HISTORIC PRESERVATION COMMISSION AGENDA ITEM EXECUTIVE SUMMARY Agenda Item Title/Address: Proposal: Window replacement Petitioner: Please check appropriate box (x) PUBLIC HEARING MEETING 8/7/13 AGENDA ITEM CATEGORY:

Windows on the house at 120 N. 4th St. were replaced without a permit. By the time the Building Division was alerted, all of the windows had already been installed and the contractor was completing the installation.

Photo: Aug. 2003

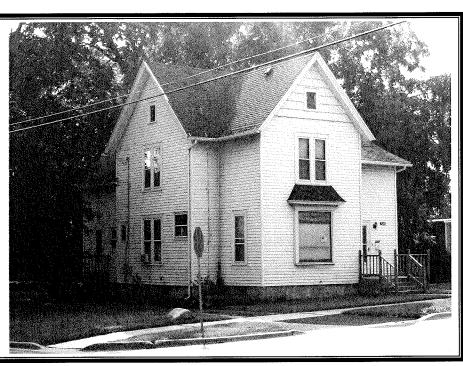
Attached is a photo of the building from 2003 showing the previous windows, which appear to have been covered in aluminum storm windows.
